THE UPDATED PROPOSAL

HEIGHT DECREASE

INCREASE IN PARKING

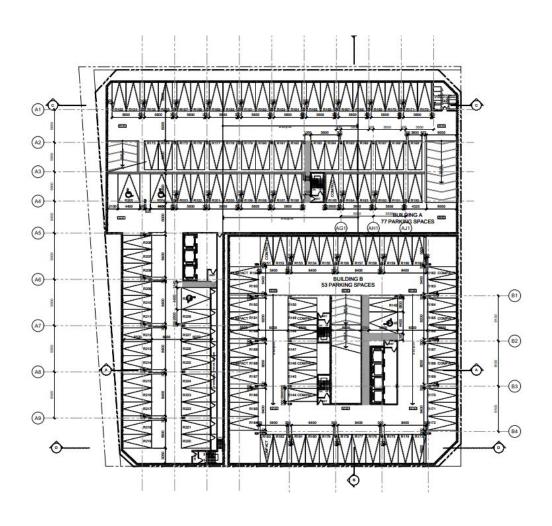
- Future success of the downtown counts on pedestrian friendliness, not vehicular friendliness.
- Current state of the downtown would be not be well served by increasing vehicle traffic.
- The site is supported very well by existing transit.
- Increased parking is counter to the success of the downtown.
- Increased parking is also counter to climate change goals.
